**TOWN OF NEWBURGH
PLANNING BOARD
TECHNICAL REVIEW COMMENTS**

PROJECT: DOLLAR GENERAL-BALMVILLE
PROJECT NO.: 20-04
PROJECT LOCATION: SECTION 24, BLOCK 4, LOT 1.12
REVIEW DATE: 26 MARCH 2021
MEETING DATE: 1 APRIL 2021
PROJECT REPRESENTATIVE: BOHLER ENGINEERING/CARYN MLODZIANOWSKI

**Re: Response to Comments Summary
Proposed Dollar General
SE Corner of US Route 9W & North Hill Lane
Town of Newburgh, New York**

SHEET TITLE:
GRADING & DRAINAGE PLAN
 SHEET NUMBER:
C-5
 REVISION 5 - 03/03/2021

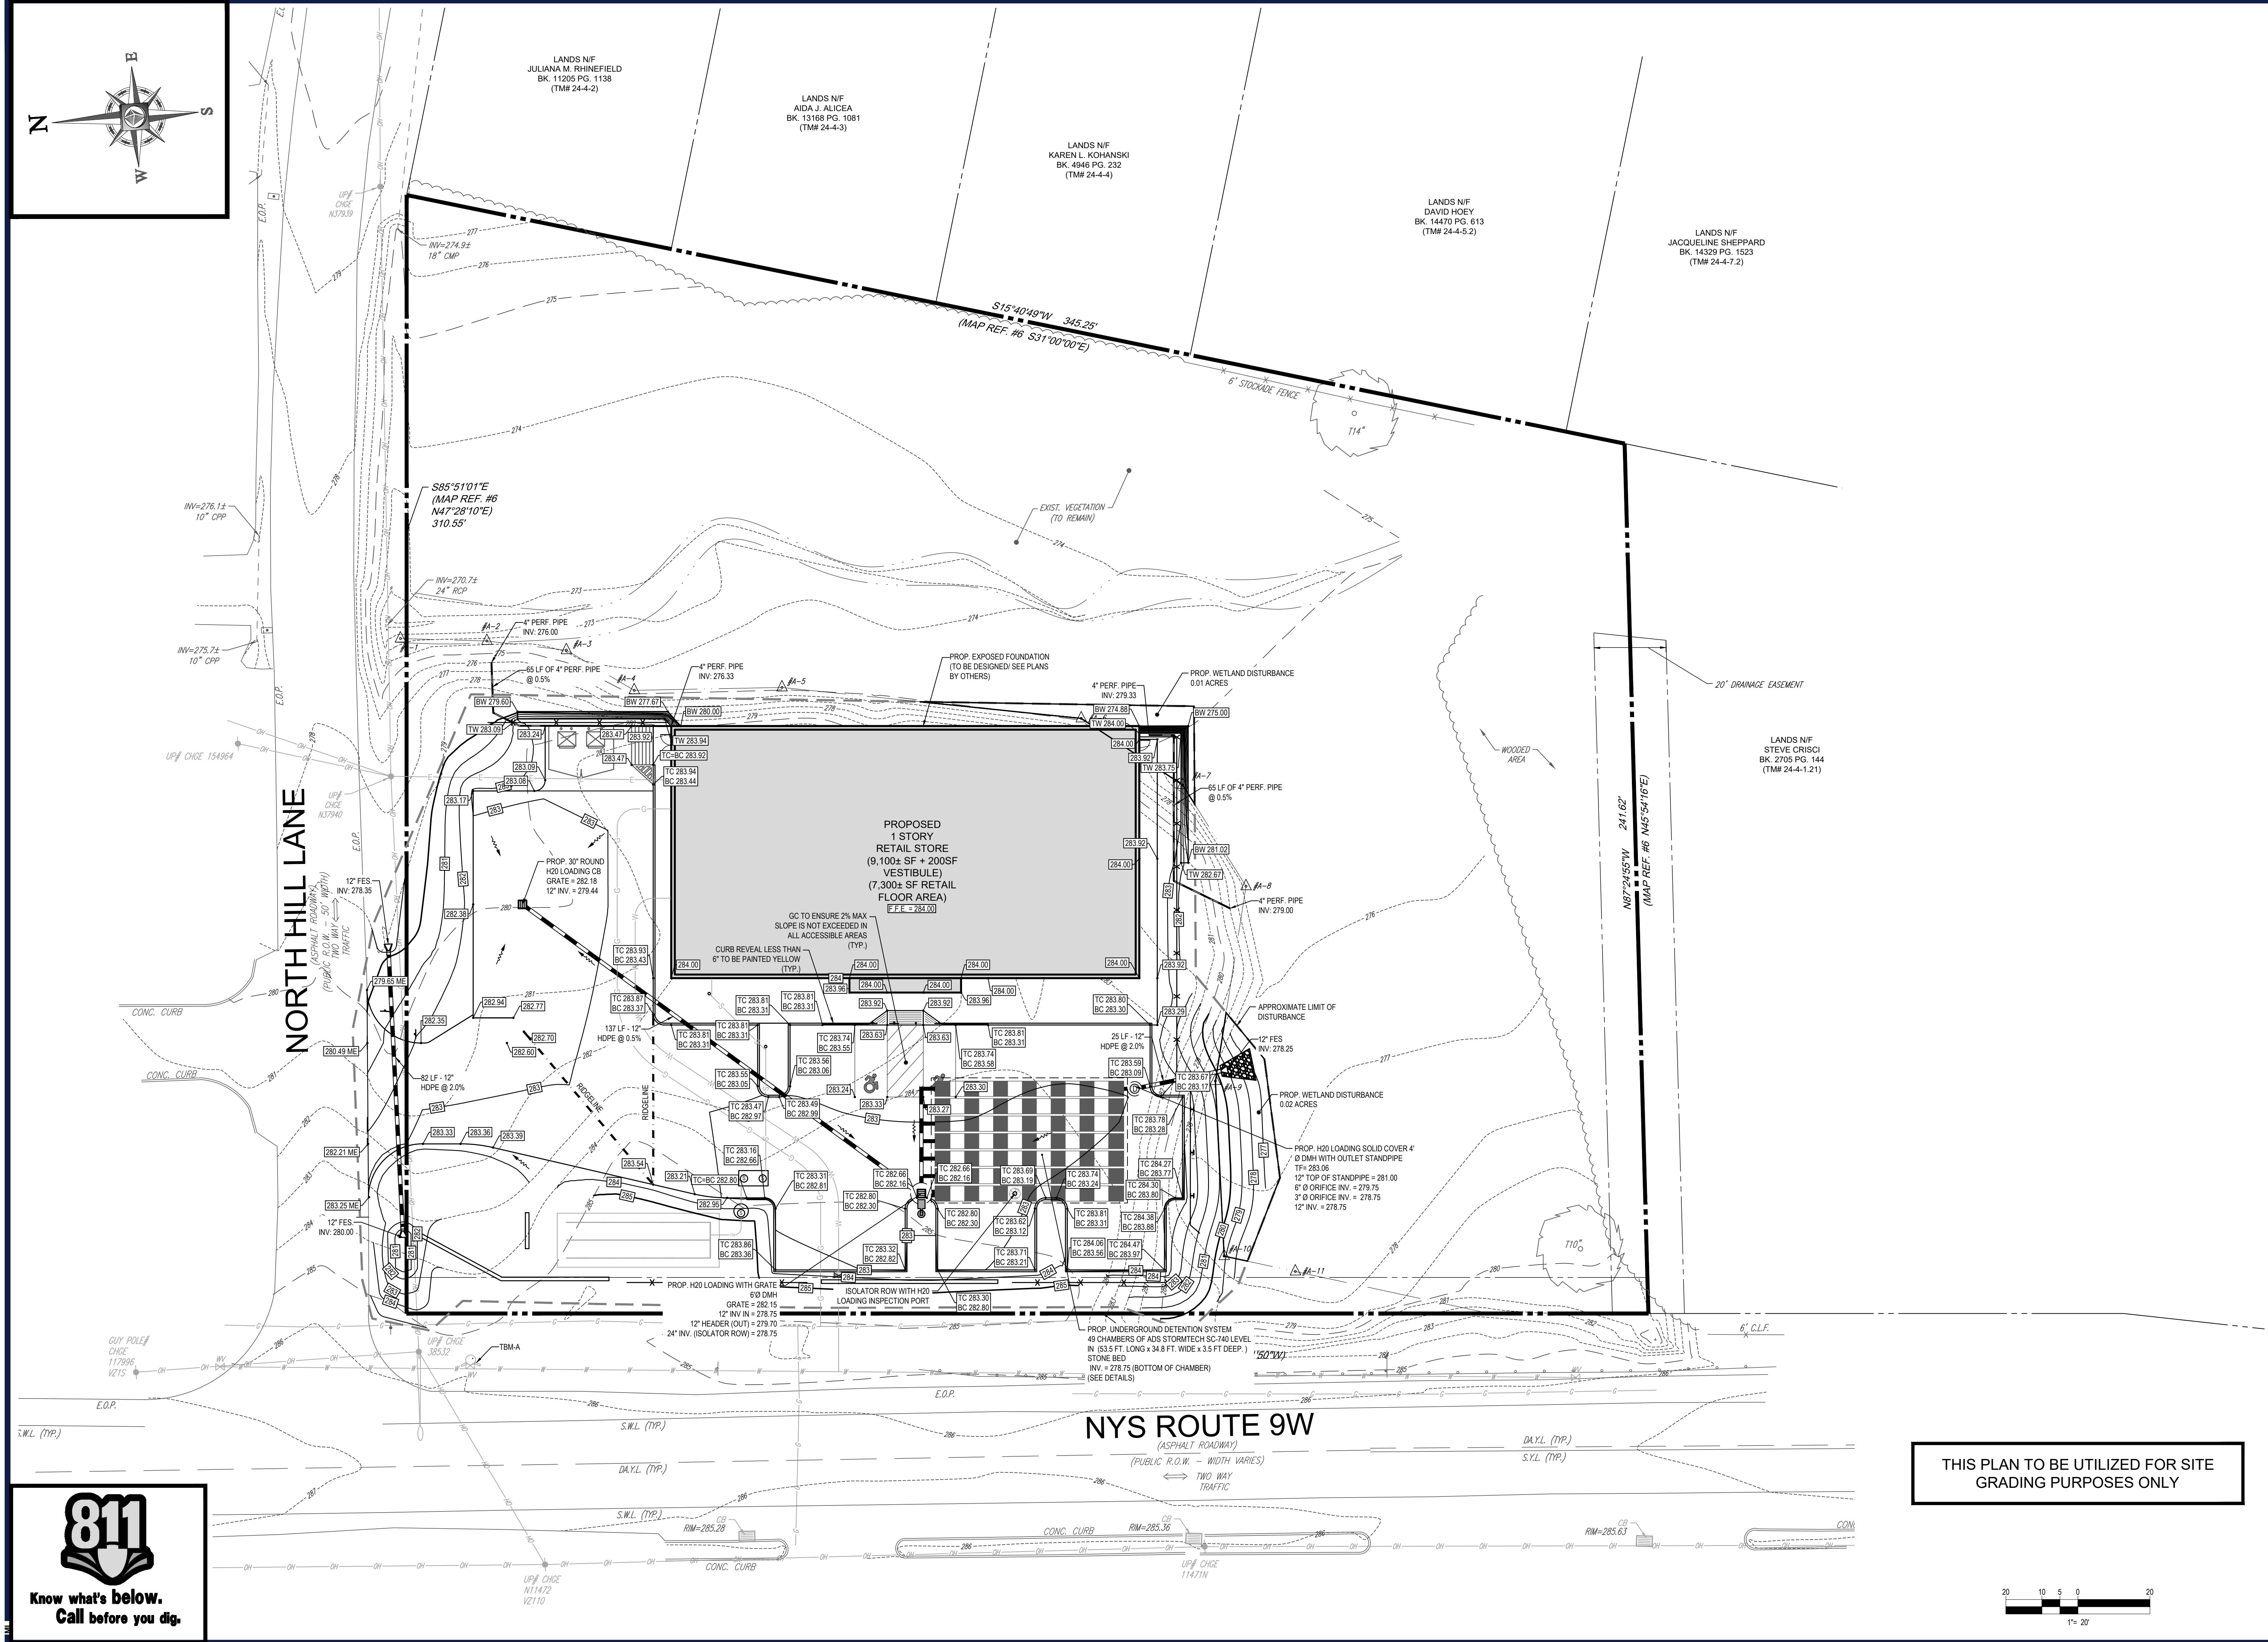
4. Our previous comments requested submission of the wetland delineation report to complete the Town's files. The Applicants representative have identified that .031 acres of wetland disturbance is proposed.

The wetland delineation was mapped by the surveyor and is shown on the survey previously provided. The proposed wetland disturbance areas are shown on the Grading & Drainage Plan.
